# *AF40 C1 Drum Update Kit.*

**TF80-SC (AF40) C1 Drum.**

**LATEST O.E. LEVEL.**

**PART NUMBER N268 29 03**

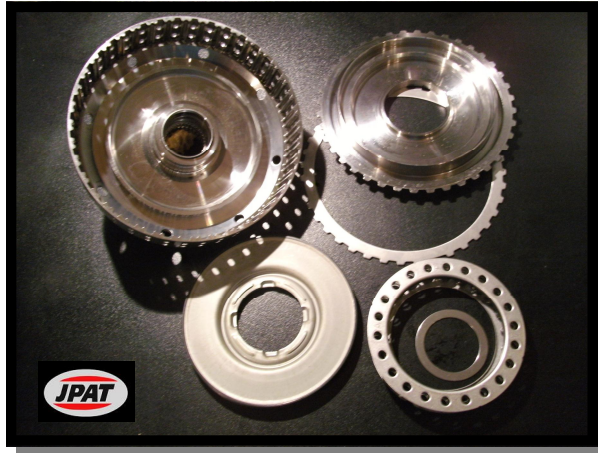
The clutch kit solves a common failure point of this transmission, causing delayed engagement into drive from startup. The problem occurs when the steel piston rotates in the housing causing a groove to form and in turn excessive clutch clearance.

This clutch kit includes a new bonded rubber damper piston that has also been updated featuring larger exhaust slots. Also included is a new set of return springs, a steel plate for adjusting clutch clearance and most importantly the new steel piston which benefits from location teeth around the outside diameter to prevent rotation, therefore eliminating the wear experienced by earlier units.
